RS-10-165

Dresden Nuclear Power Station, Units 2 and 3
Renewed Facility Operating License Nos. DPR-19 and DPR-25
NRC Docket Nos. 50-237 and 50-249

Subject: Follow-up Information Supporting the Request for License Amendment
Regarding Shutdown Cooling System Isolation Instrumentation

**Follow-up Information Supporting the Request for License Amendment Regarding
Shutdown Cooling System Isolation Instrumentation**

Sketch of the Proposed Circuit Layout for
Shutdown Cooling System Instrumentation Logic

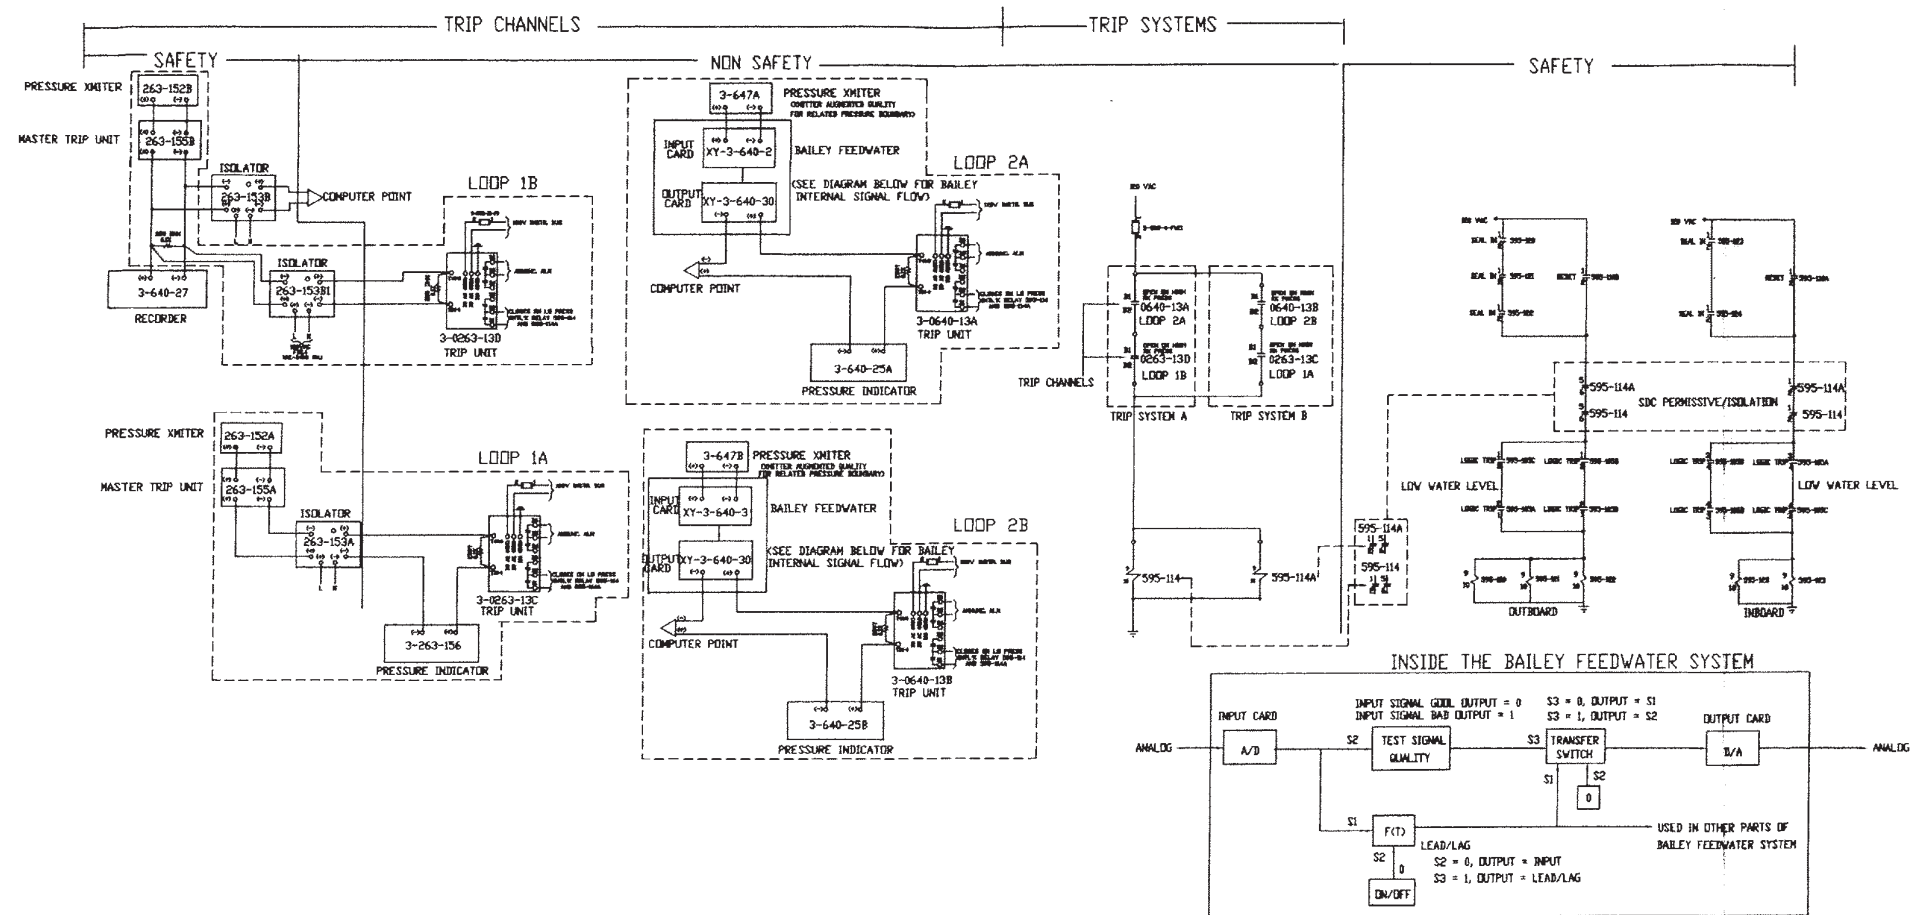
The LAR and RAI responses remain inconsistent with respect to the definition of Trip Channels, Trip Strings, and Trip Systems. While some clarification was derived, the remaining inconsistencies prevent one from determining the adequacy of the LCO Operability requirements for the SDC Isolation Trip Channels on Reactor Vessel Pressure-High. Based upon the figure provided by the licensee on page 153 of the RAI response, the proposed Tech Spec B 3.3.6.1-18 statement "Therefore all four channels are required to be OPERABLE to ensure that no single instrument failure can preclude the isolation function" appears to be the true licensee intent; however, the LAR proposed Table 3.3.6.1-1 continues to state "REQUIRED CHANNELS PER TRIP SYSTEM" as "2."

As necessary, provide responses to address inconsistencies between the definitions and sketch provided for RAI Response #5 and the associated Technical Specification use of the terms.

The Reactor Vessel Pressure – High Function receives input from four reactor pressure channels. Each pressure channel inputs into one of two trip systems. Two pressure channels make up a trip system in a one-out-of-two taken once logic arrangement and both trip systems must trip to cause an isolation of the Shutdown Cooling (SDC) valves. Therefore, the trip systems are arranged in a one-out-of-two taken twice logic configuration. The above referenced figure has been revised to reflect the terminology described here. The revised figure can be found in Enclosure 1 to this Attachment.

The sketch provided previously in RAI response 5 and the associated mark-ups of the TS Bases sections provided in Attachment 2 to Reference 2 have been revised to reflect

this description of the logic. The revised sketch is provided as Enclosure 1 to this Attachment and the revised Bases mark-ups are provided in Attachment 2 to this letter.
